PLANNING TECHNICAL REVIEW COMMITTEE –AGENDA

1. 10:30 AM - 11:15 AM: Site Review for VC Dover Investment, LLC, Assessor's Map H, Lot 4-3-1, zoned Commercial, located at 30 Grapevine Drive. (Proposal is to build a new 15,040 sf (footprint), 4 story mixed use building next to the Hannaford's Grocery Store on Grapevine Drive.) (P22-72/SITE-2022-0017). *[This item was previously heard on November 17, 2022, January 5, 2023 & February 16, 2023]*

**Re: Dover Fields, Unit 2
Site plan and CUP**

Response to TRC Comments
Mixed Use Development – Dover Fields
30 Grapevine Drive Dover NH, 03820
Tax Map H-4-3

46001.31 DR JMR FB 1927 SHEET 6 OF 23
CK JK CADFILE 46001-31 CONCEPT

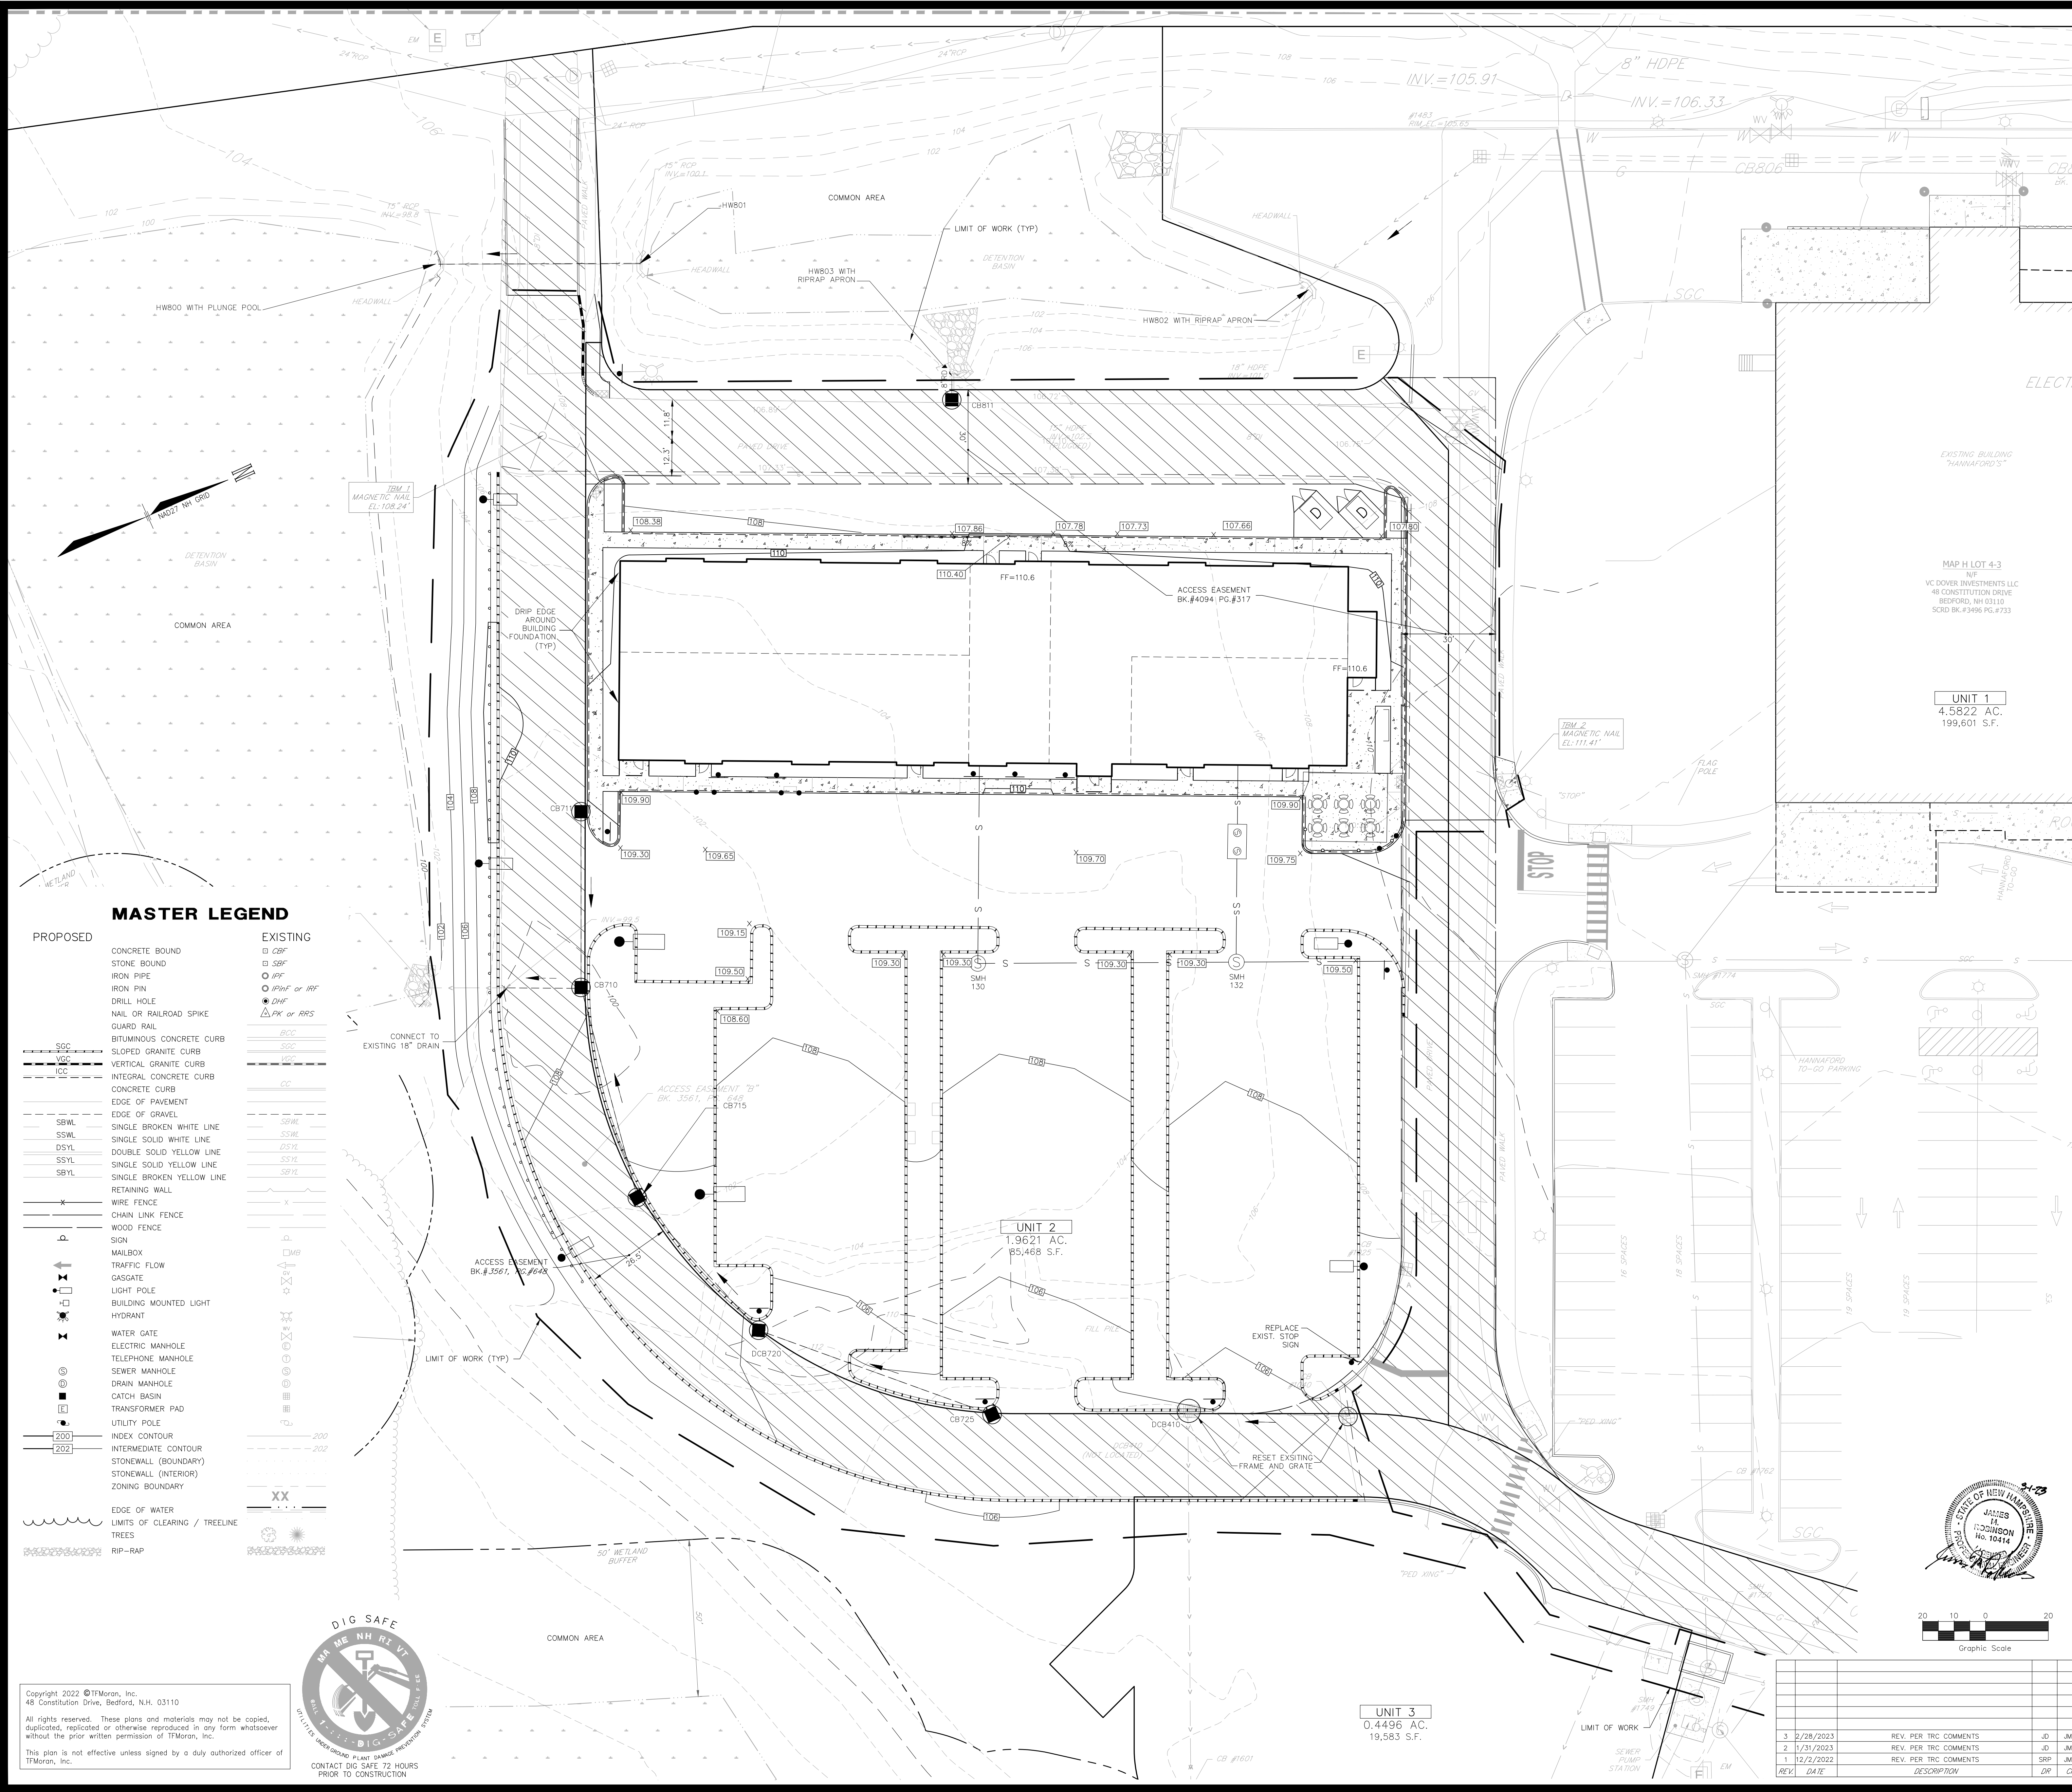
- Sheet 6 of 23: Note 14 refers to roof drains. Please clarify where these are or remove note.
- Sheet 6 of 23: Note 24 refers to infiltration, filtering, and underground detention systems. Please clarify where these are or revise note.

TAX MAP H LOT 4-3
SEWER AND DRAINAGE PLAN & PROFILE
MIXED USE DEVELOPMENT

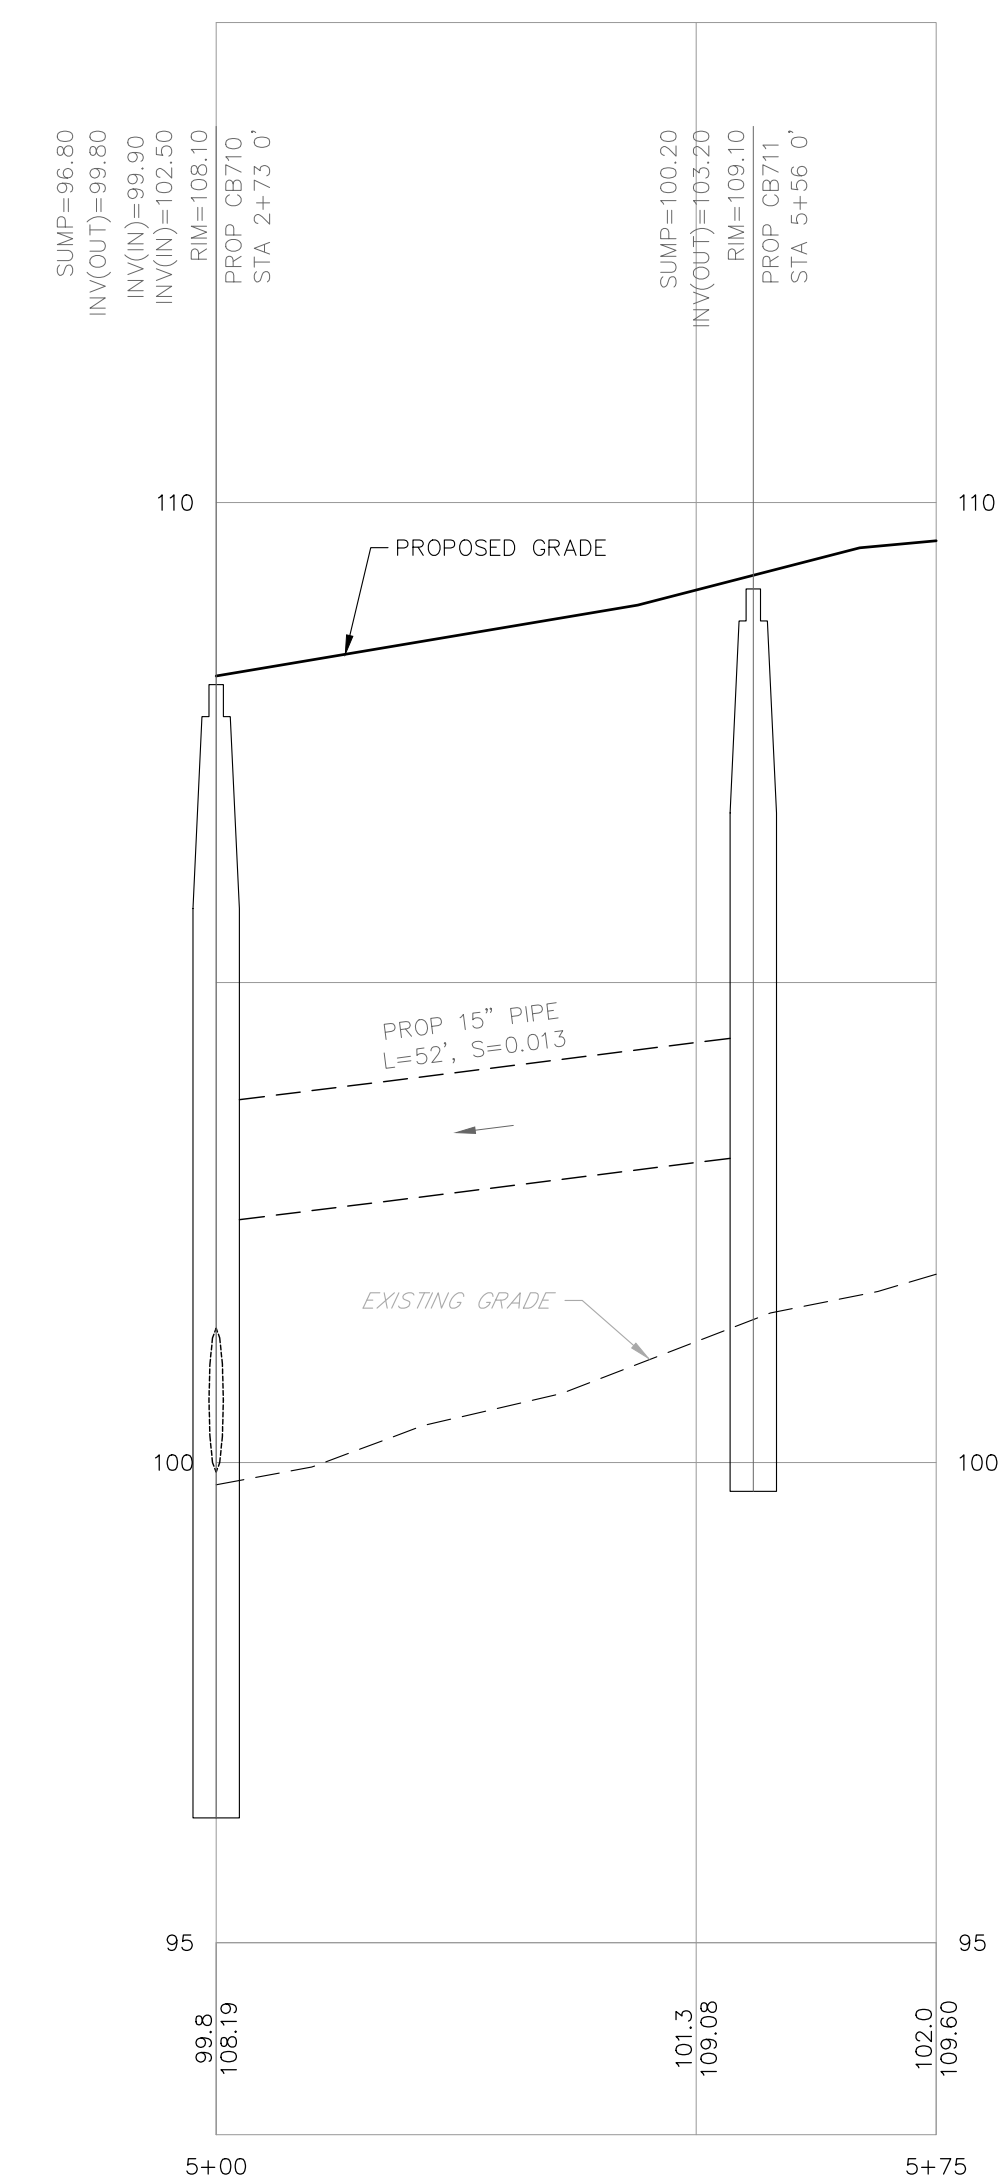
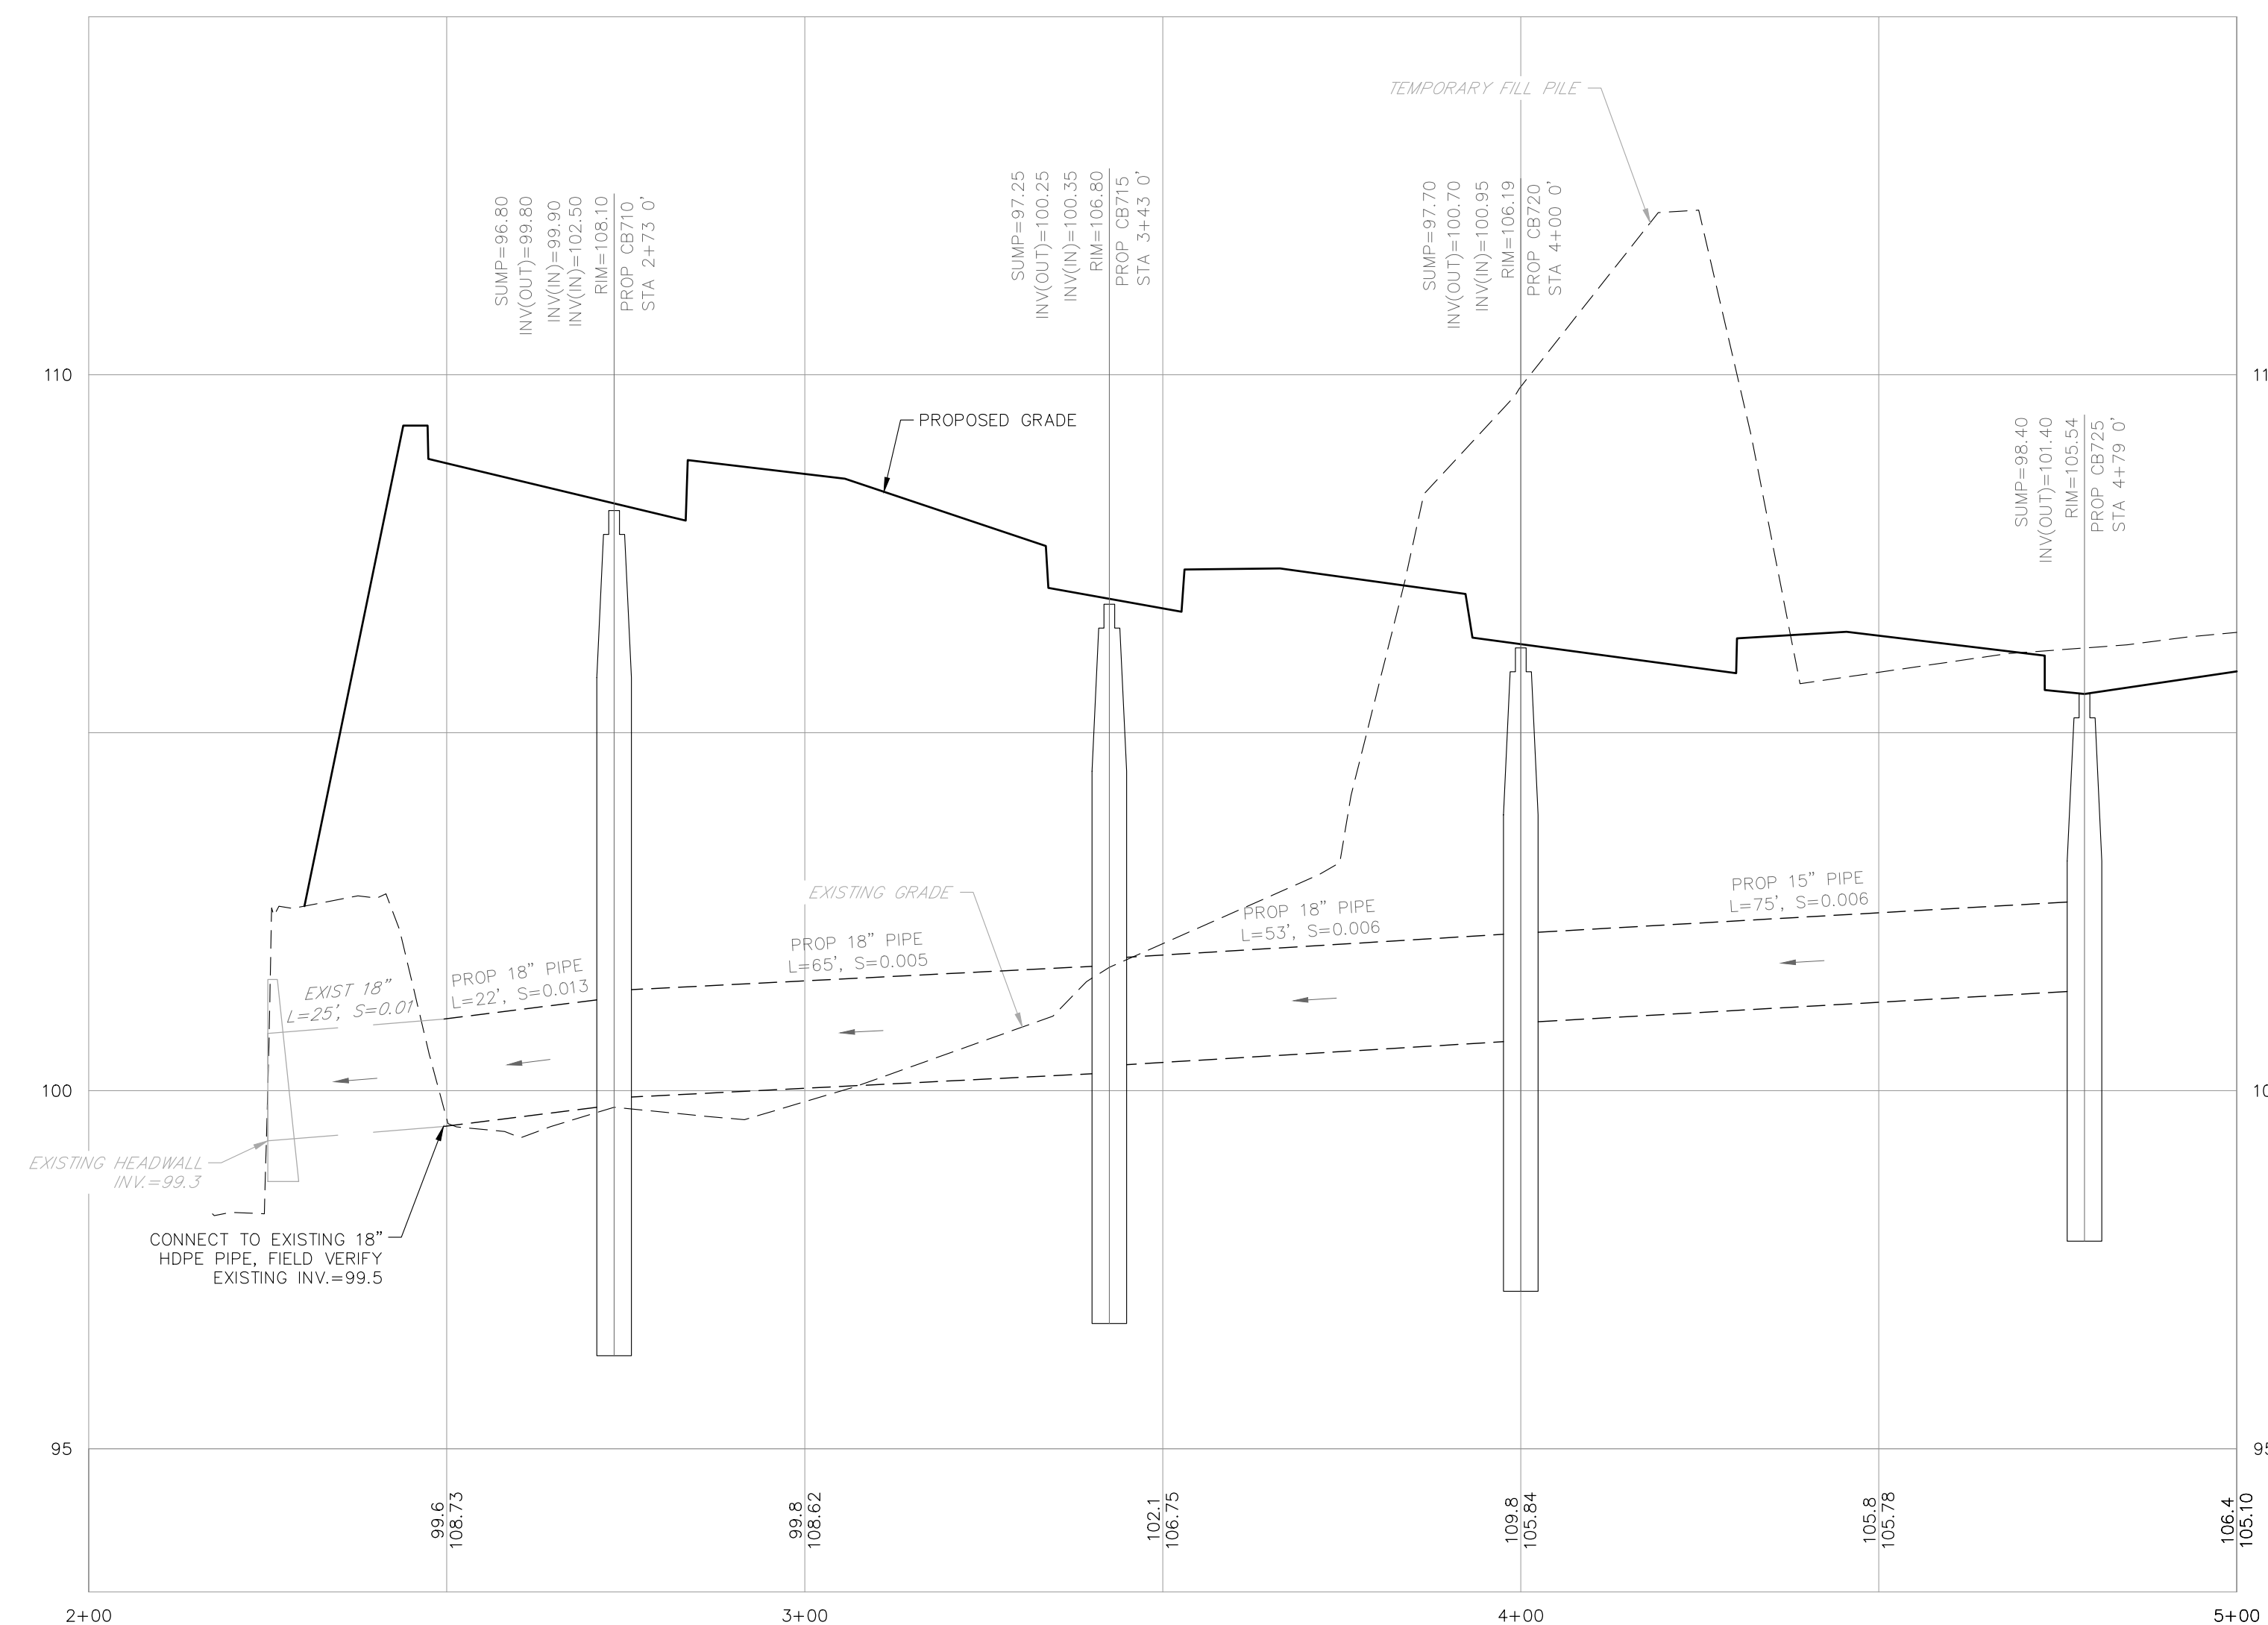
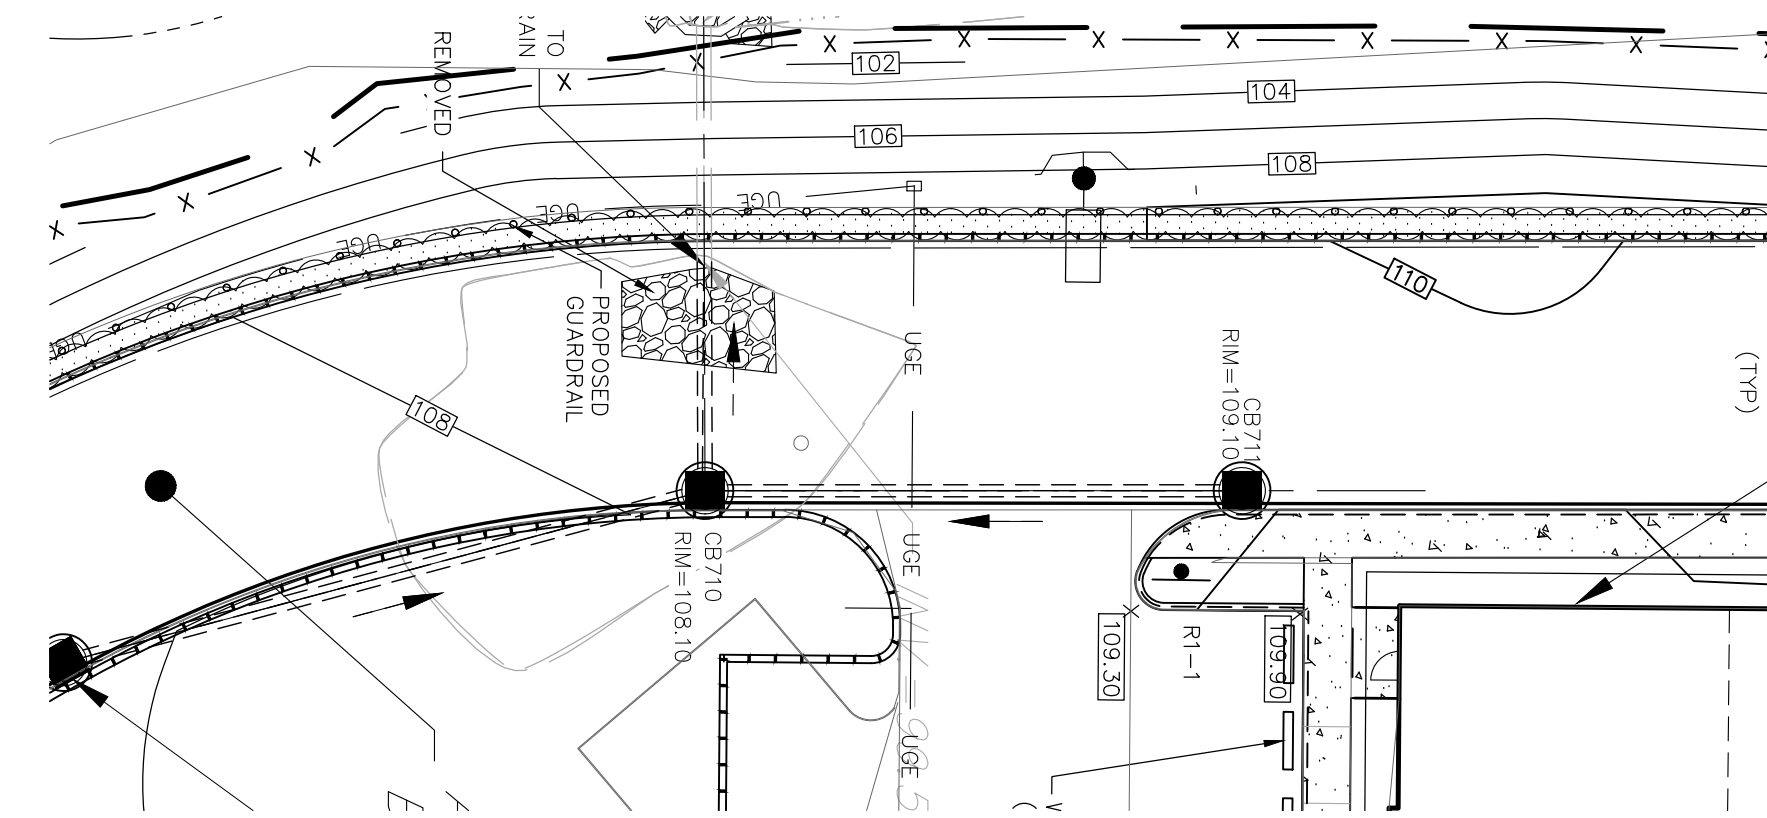
- Sheet 7 of 23: Recommend providing SMH where grease trap line ties into the 8-inch main.
- Sheet 8 of 23: Light Poles appear to be missing from the plan. Verify poles will not conflict with landscaping.
